Swan_soundbar_DVT1_review v0.1

ALT Co., Ltd.

Issued Date 2021.02.19

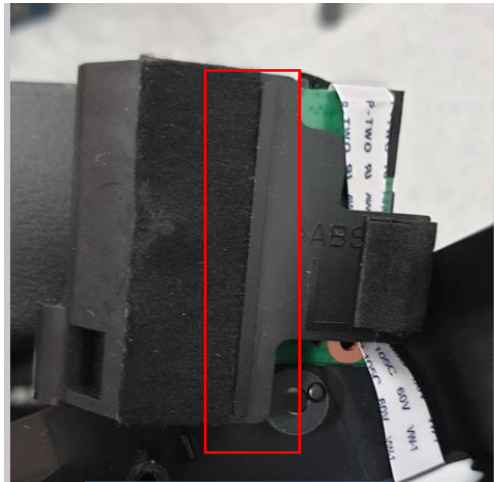
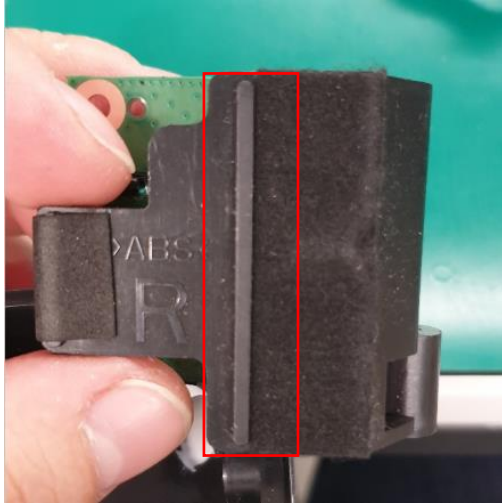
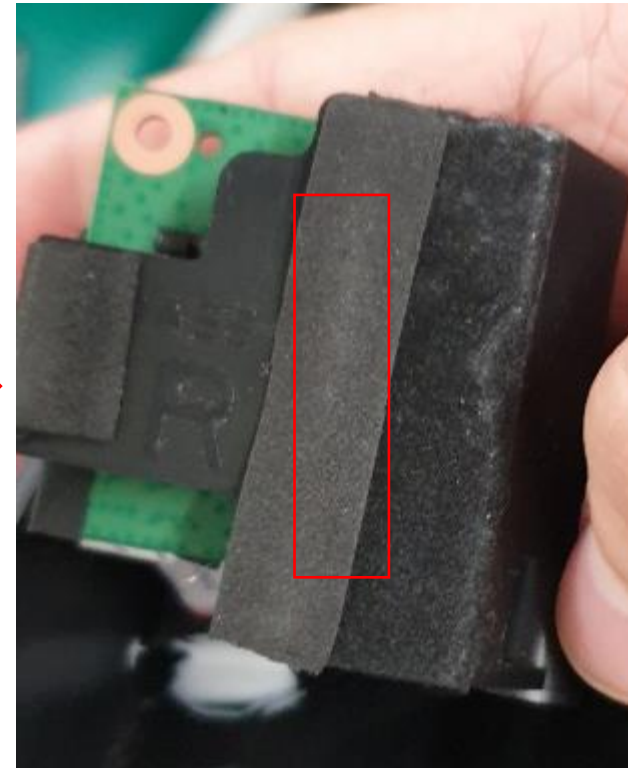
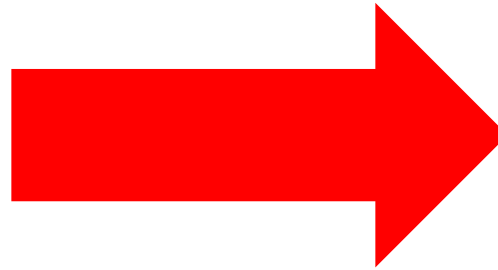
- Gasket for side led attachment NG

NG

OK

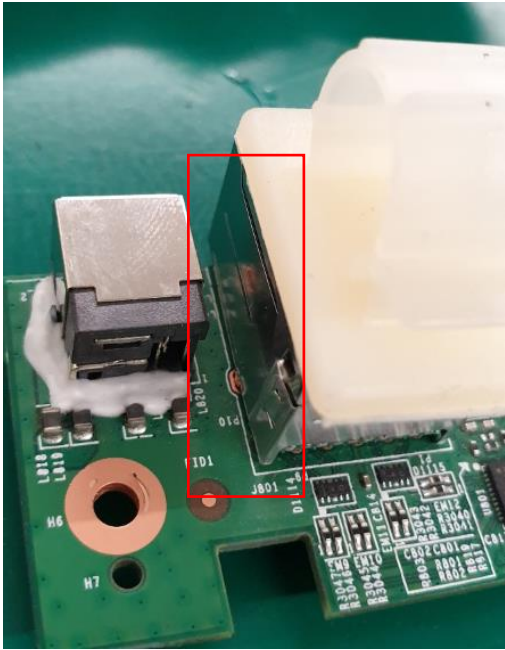
- The Glue is missing on the Ethernet connector side

NG

OK

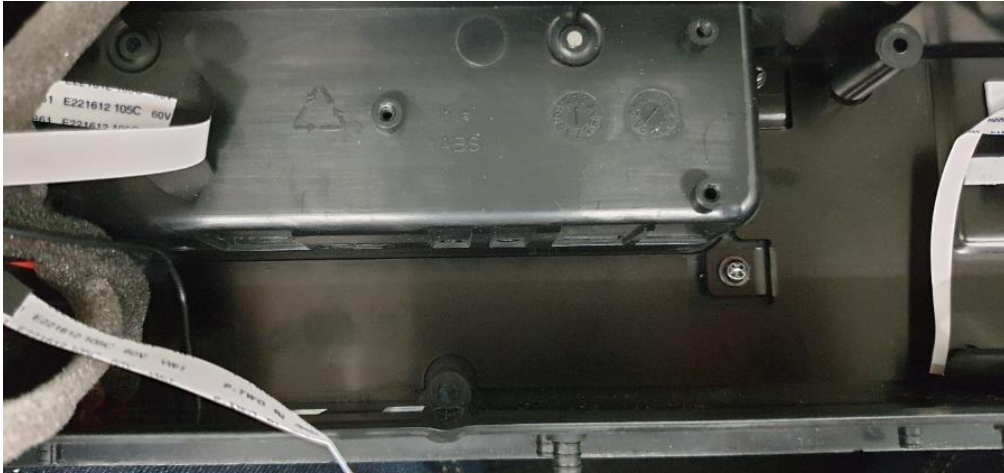
- LED light pipe vibration

NG

OK

- Temporary solution for DVT2
 - Apply glue between LED light pipe and side LED PCB

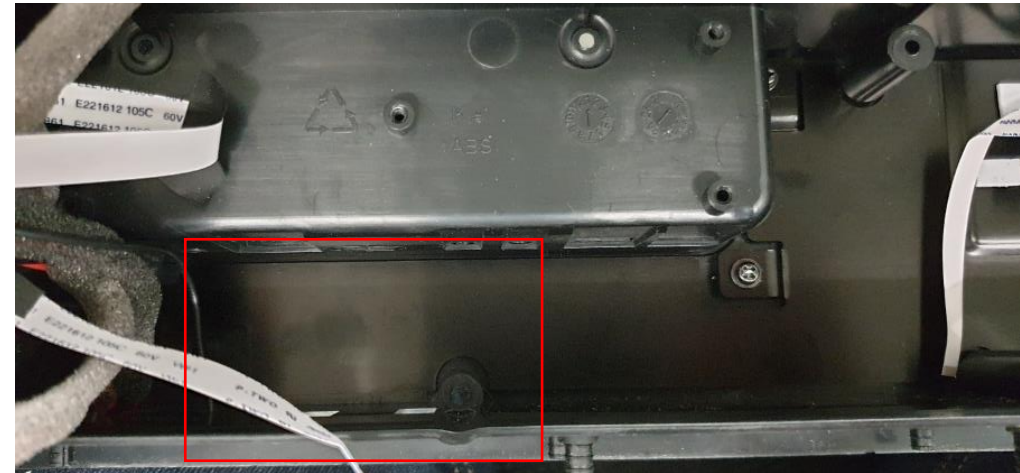
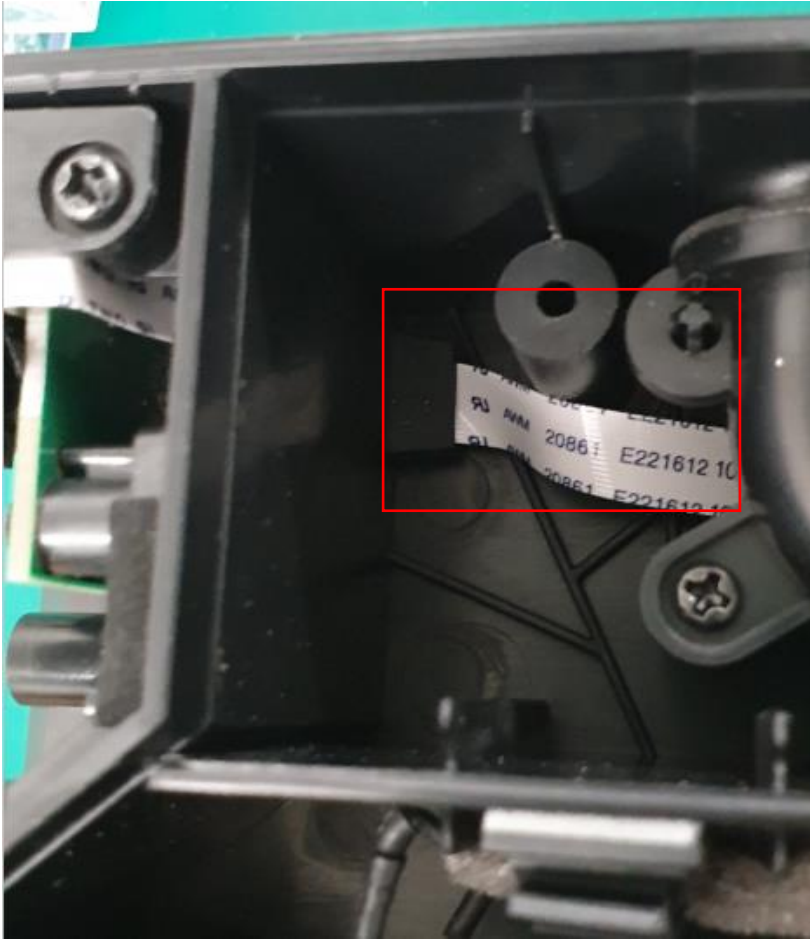
- Noise and vibration between SOC_BOT heat spreader and bottom housing

NG

OK

- Temporary solution for DVT2
 - Apply Non-woven between bottom housing and soc_bottom heat spreader

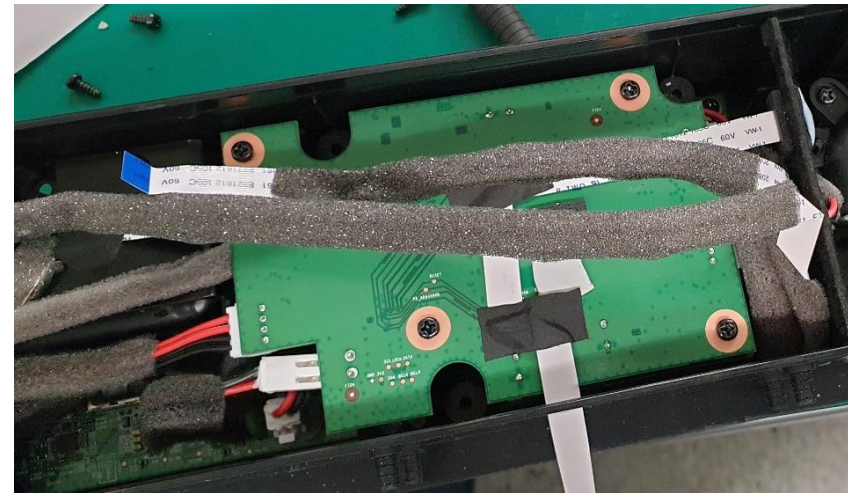
- FFC for side LED folding NG

NG

OK

- Temporary solution for DVT2
 - Folding FFC cable like below,
 - To fix the cable to prevent Noise and vibration

- All of cables (FFC, Antenna cable) should be warped with sponge

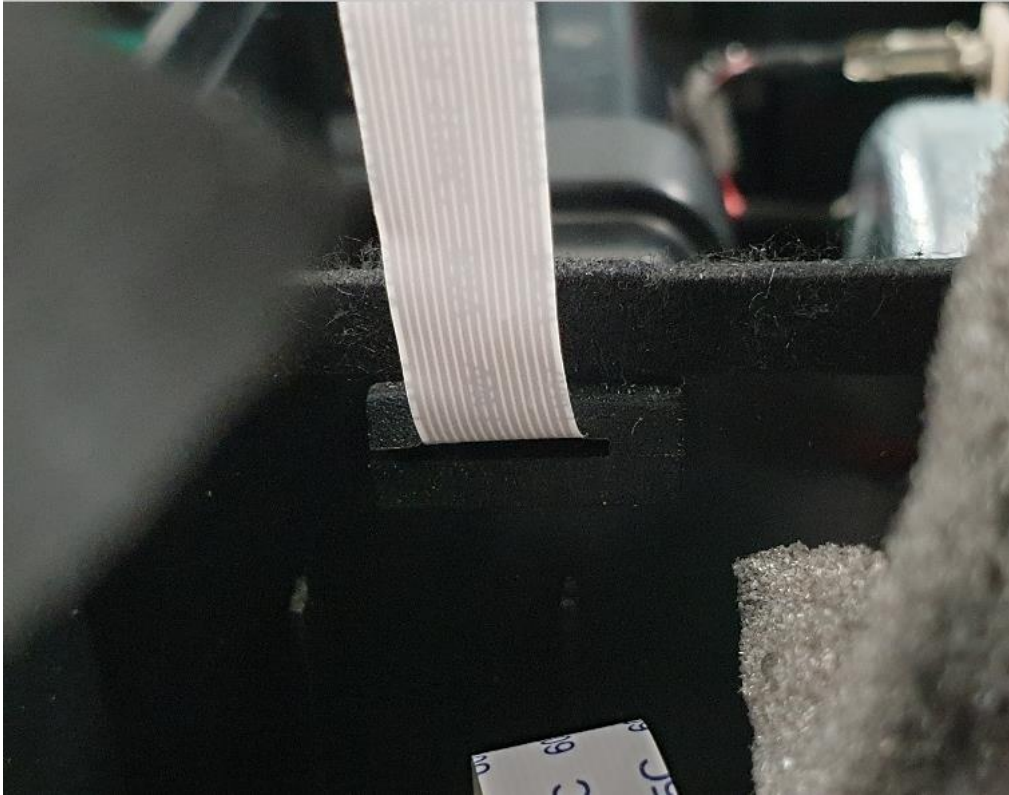
NG

OK

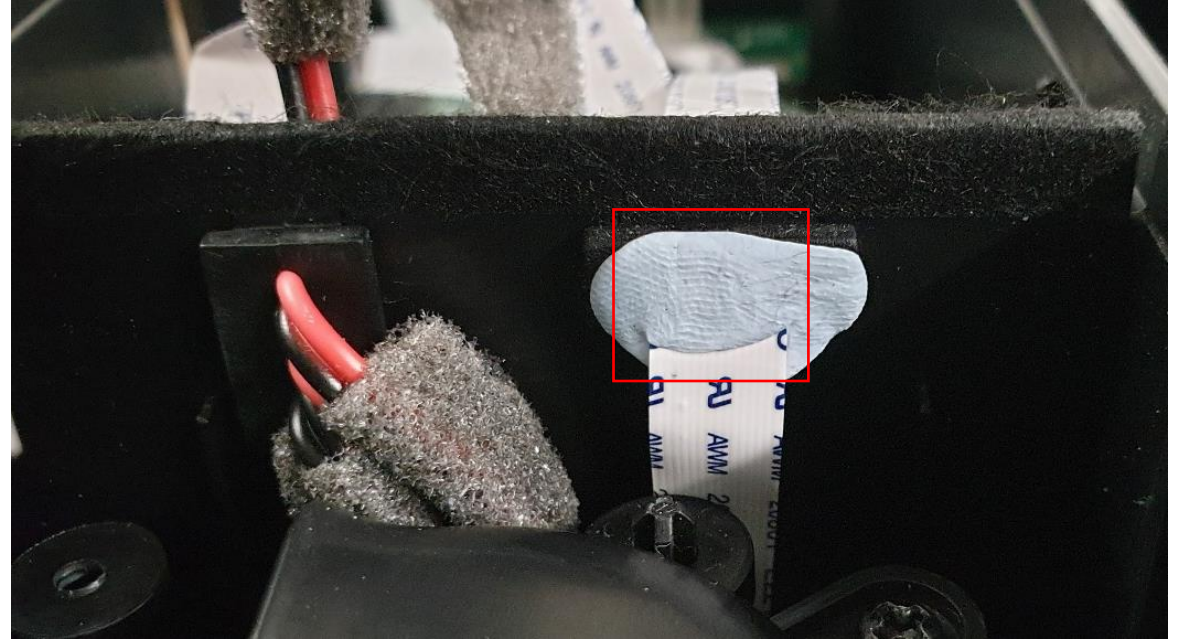
- Side LED bushing : Not to fully sealed.

NG

OK

- Temporary solution for DVT2
 - Apply glue instead of clay
